CALVERT CLIFFS
NUCLEAR POWER PLANT

SUBJECT: Calvert Cliffs Nuclear Power Plant
Independent Spent Fuel Storage Installation
Material License No. SNM-2505, Docket No. 72-8
Response to Request for Additional Information, RE: Calvert Cliffs Independent
Spent Fuel Storage Installation License Renewal Application (TAC No. L24475)

CALVERT CLIFFS RESPONSE FOR RAIs

Figure 2-1. Proposed DSC Aging Management Program for the Effects of CISCC

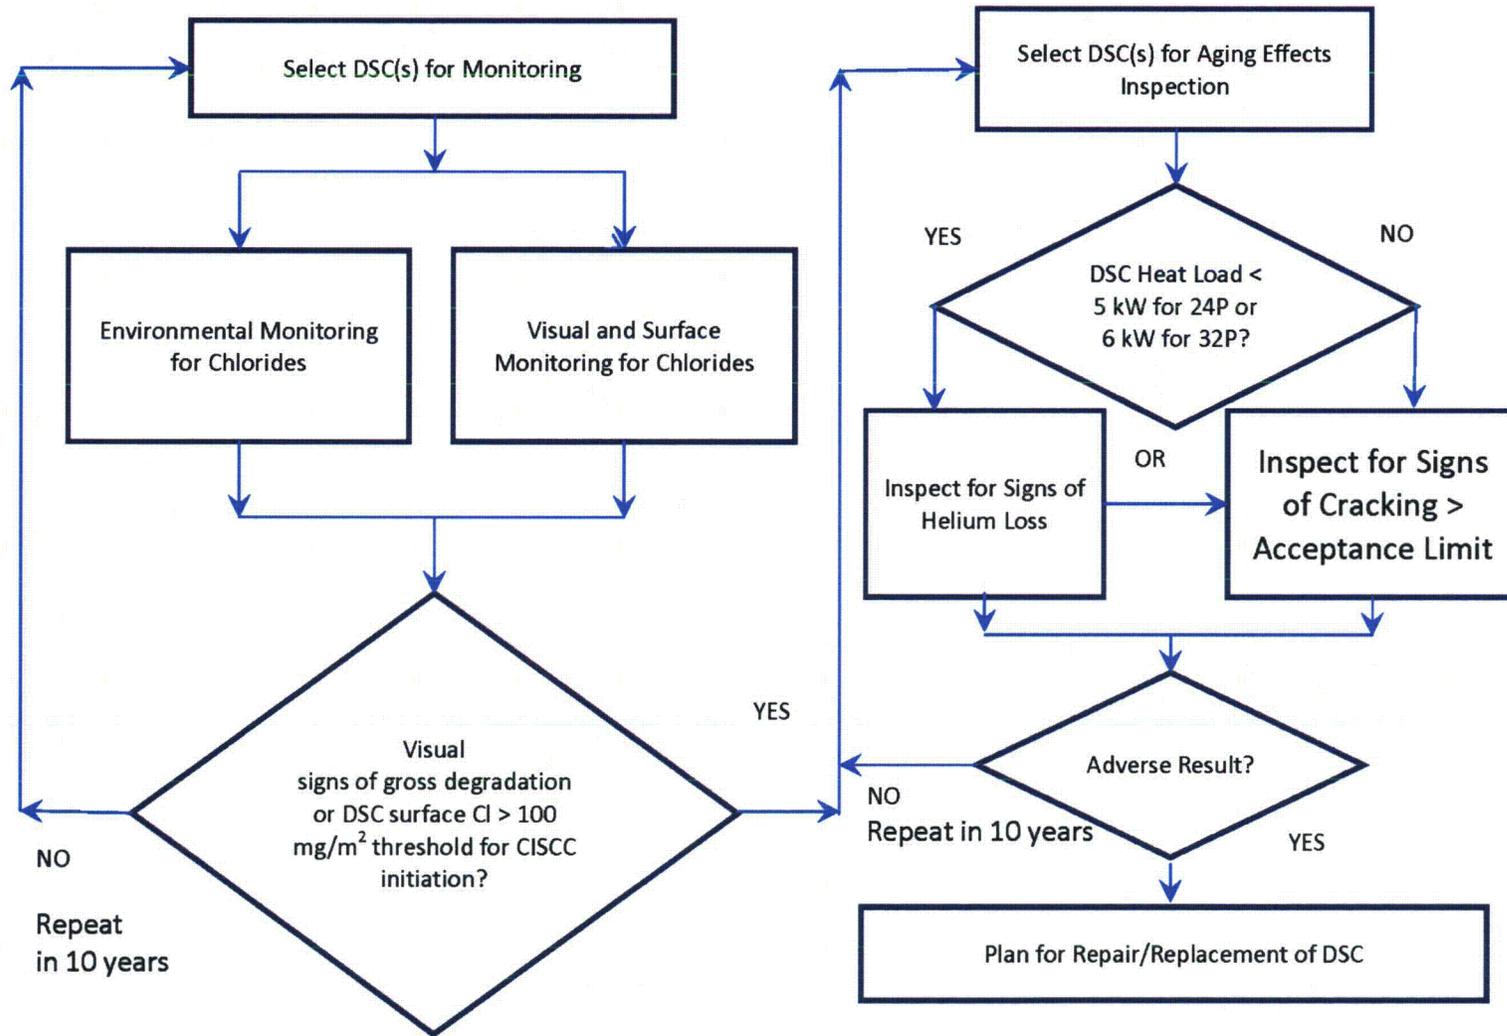
E-2 Provide a revised proposed aging management plan that considers the potential for SCC at the CCNPP ISFSI.

Publicly available research has indicated that SCC may occur in regions of strained, sensitized austenitic stainless steel when atmospheric chlorides are present (ADAMS Accession Number: ML12128A133). The thermal and strain conditions of the canister and internal HSM atmosphere are not completely understood, and it is unclear whether SCC could result in degradation of the confinement integrity during the renewal period without a sufficient monitoring and mitigation program.

The applicant should develop a process for periodically incorporating on-going SCC evaluations and knowledge gained by the industry's generic program to identify designs and conditions susceptible to SCC and associated mitigation recommendations. The aging management program may also need to consider interim measures to verify the DSC time-limited aging analyses and confinement integrity during the requested license renewal period.

The original Calvert Cliffs ISFSI License Renewal Application did not identify any aging effects for the DSC that required aging management (Reference 2-1, Table 3.3-1). This conclusion was consistent with the NRC approval of the license renewal for a NUHOMS® ISFSI of similar design for a 40-year license renewal period slightly more than one year prior to the Calvert Cliffs submittal (Reference 2-2, Section 3.2.4). The Reference 2-2 approval is indicated to be based on the fact that “Each DSC is placed into an HSM and, thereafter, exposed to only a mild ambient environment. There are no aging effects requiring management of the stainless steel or lead subcomponents of the DSC’s because of the corrosion-resistant materials of construction, double seal-welded closure, and the environments to which each DSC is exposed.” However, Calvert Cliffs understands that CISCC may be a special concern due to the possibility of chlorides in the environment as a result of its proximity to a body of brackish water (i.e., the Chesapeake Bay). Based on the analysis and inspection results discussed in the response to RAI E-1, we believe that the aging management program for the effects of CISCC should be done using a phased approach similar to that recommended in Reference 2-3. Figure 2-1 summarizes the proposed phased aging management program for the Calvert Cliffs DSC’s to address the potential effects of CISCC.

Calvert Cliffs will continue to perform visual inspections of the DSCs during the interior visual inspection required for aging management of the HSMs. We will perform this inspection on a 10-year frequency in a manner of equal or better quality to that performed in June 2012. We believe this may still be a valuable general aging indicator for the exterior of the DSC. Both the accelerated aging CISCC tests in high chloride environments in References 2-3 and 2-5 show areas of high density localized rust spots in

Environmental Monitoring for Chlorides – The results of the June 2012 inspections and the analyses discussed in the response to RAI E-1 suggest that chloride concentrations on the oldest Calvert Cliffs DSCs still appear to be well below the proposed 100 mg/m² initiation threshold for CISCC indicated by laboratory results, and that they would be expected to remain so for many years. As such, we believe it is premature to begin detailed DSC surface inspections for the effects of CISCC. We believe that the more prudent and dose sensitive approach is to first obtain additional data on the chloride concentration on the DSC surface via both wet and dry sample collection methods similar to that performed in June 2012. We would propose to perform this sampling on different positions on the canister surface to represent a spatial variation of the chloride concentration. We would perform this sampling on a 5-year frequency (starting from the June 2012 inspection) for the first 10-years, after which the frequency would be increased to 10 years to coincide with the timing of visual inspections of the HSM provided trending indicates the threshold concentration would not be exceeded within 10 years.

In addition, we would propose to establish a monitoring program for airborne chlorides in the vicinity of the ISFSI. We are exploring whether the filters presently being used in the airborne particulate monitors SFA3 and SFA4 credited for the Radiological Environmental Monitoring Program can be utilized to characterize the airborne chloride concentration (several years worth of these filters are currently archived). An alternative or supplemental option may be to deploy monitoring stations specific to airborne chloride measurement. The intent would be both to validate the RAI E-1 response expectation of low airborne chloride content in the vicinity of the ISFSI, as well as to support validation of the correlation between airborne chloride content and DSC surface chloride concentration. We would commit to establishing this airborne chloride monitoring capability in some form within 5 years of renewal of the Calvert Cliffs ISFSI license. After 10 years, the continuance of the program would be re-evaluated. If the existing correlation with DSC surface chlorides is validated, or a new site-specific correlation developed, the airborne chloride monitoring may be continued in place of the surface chloride sampling discussed above. Otherwise, the airborne chloride monitoring program may be discontinued since surface sampling would be more representative of the actual chloride concentration present on the DSC.

Inspection for the Effects of CISCC – Once the proposed environmental monitoring program identifies confirmed chloride concentrations on the surface of a DSC which exceed the proposed 100 mg/m² limit for initiation, Calvert Cliffs would propose to perform an inspection to look for the effects of CISCC on the surface within 5 years, with subsequent inspections performed on a 10-year frequency thereafter. The initial 5-year period is based on the fact that flaw growth rate calculation in Enclosure 4 suggests that a CISCC induced crack would not grow farther than the minimum DSC shell thickness assumed in stress analyses and the 10 year frequency is substantially below the 48-year time to propagate through-wall determined in Enclosure 4.

The inspections could take one of two forms: 1) a surface inspection to look for cracking in the DSC shell, or 2) an inspection to look for indication that the helium inside the DSC has been lost via non-destructive means if the DSC heat load is less than 5 kW for a 24P DSC, or 6 kW for a 32P DSC (with the heat loads based on the results of Enclosure 5 and the consequence discussion in the RAI E-1 Response). The methods for the former option will utilize appropriate available nondestructive examination techniques for identifying CISCC remotely on high dose rate DSCs in-situ, as directed by a Calvert Cliffs site Non-Destructive Evaluation Level 3 qualified individual. Research and development by NRC, U.S. Department of Energy, EPRI, and Industry on nondestructive examination tooling for such inspections

Both techniques will require an acceptance criterion to determine whether the depth of any CISCC observed represents a potential loss of the structural function of the confinement boundary. This acceptance criterion will be based on a critical flaw calculation assuming a crack has propagated through DSC shell. Since Enclosure 4 demonstrates that only cracks which are oriented perpendicular to the weld will propagate through the full thickness of a DSC shell, cracks in the hoop direction will be evaluated for axial stresses and cracks oriented in the axial direction will be evaluated for hoop stresses. The initial length of all cracks evaluated will be limited to the thickness of the location of the respective weld. Calvert Cliffs will commit to perform this evaluation within 5 years of approval of the ISFSI License Renewal.

If the presence of CISCC exceeding the acceptance criterion is confirmed, a repair or replacement plan for the DSC will be implemented, with timing commensurate with the consequences of through-wall CISCC.
